ORIGINAL
UNITED STATES
NUCLEAR REGULATORY COMMISSION

BEAVER VALLEY II

APPEALS MEETING

DATE: THURSDAY, FEBRUARY 28, 1985

FIGURE AI-1
 FIRE HAZARDS ANALYSIS PLAN
 ARRANGEMENT-PERSONNEL
 ACCESS BETWEEN BUILDINGS
 LOWER ELEVATIONS
 BEAVER VALLEY POWER STATION
 UNIT 2

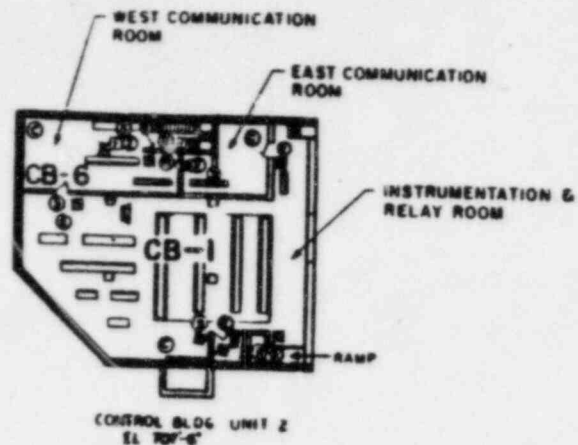
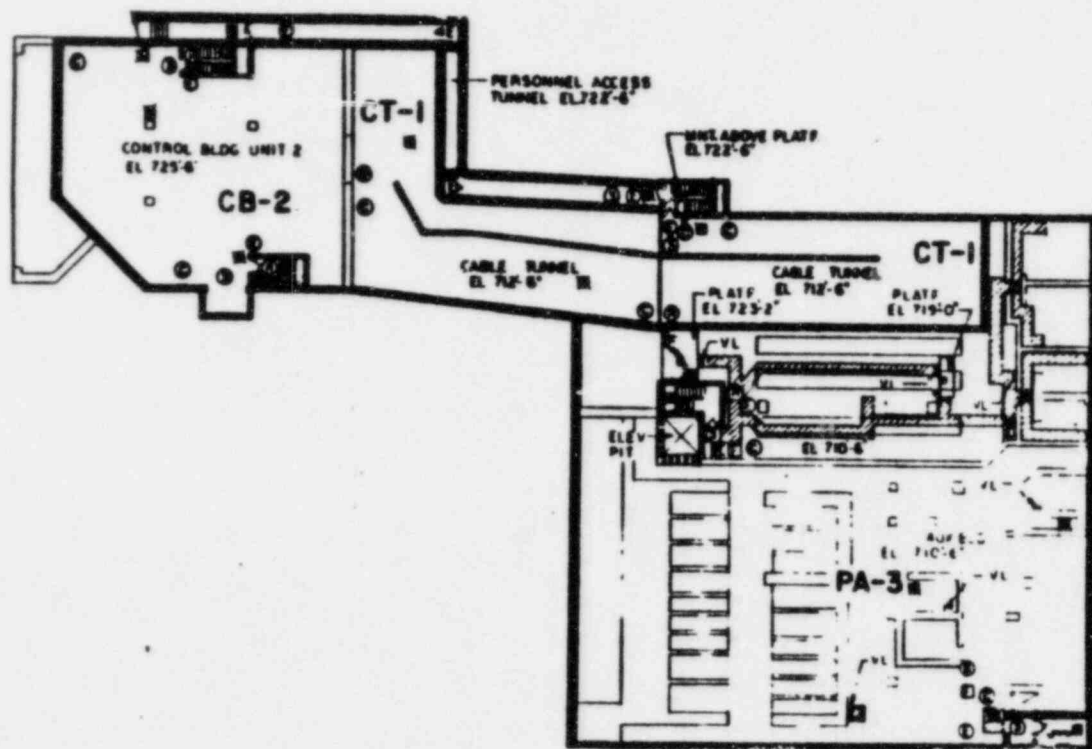
21 This figure is not in the fire protection
22 report. It was simplified from several figures that are in
23 the report. The report contains maybe a smaller version of
24 this in Figure A-1-A, and this has been in the staff's
25 hands for several months. But this is a simplified version

1 MR. EILMANN: You really can't tell that from
2 drawings because we don't have section views down the
3 aisles that shows you the walkways. That is not the typical
4 drawing that is designed for electrical cable trays.

13 MR. THOMPSON: And I guess that is the
14 furthestest, or I can't tell from this one where your hose
15 is. Maybe you could show me where that is on the other
16 slide.

20 MR. JOHNSTON: It is the problem of accessibility
21 to manually fight the fire in the area of the vertical
22 cable trays, particularly at the far end of their drawing.
23 And the other thing was that since the hose station is
24 located in the room that would presumably be used to fight
25 that one instead of being outside, to what extent that is a

9 MR. EILMANN: We have rack at a level above this
10 which the brigade will use to enter this room, and as they
11 enter that room if the fire is on that rack and it burns
12 up that hose, then we will bring in an additional hose and
13 assemble the hose and fight the fire from there in that
14 direction. But we do have a hose at the next level. I did
15 not show it here because at this elevation there is not a
16 rack in this hall. It is at the second elevation up, and
17 that hose will be used to enter that room with a fog spray
18 type of device.

21 MR. EILMANN: We will have a platform over it so
22 you can walk over it. The point I want to add to Jack's is
23 that the vertical trays are located prior to the point
24 where you have to crawl under. So the obstacle getting to
25 the vertical problem in this room is just going over that
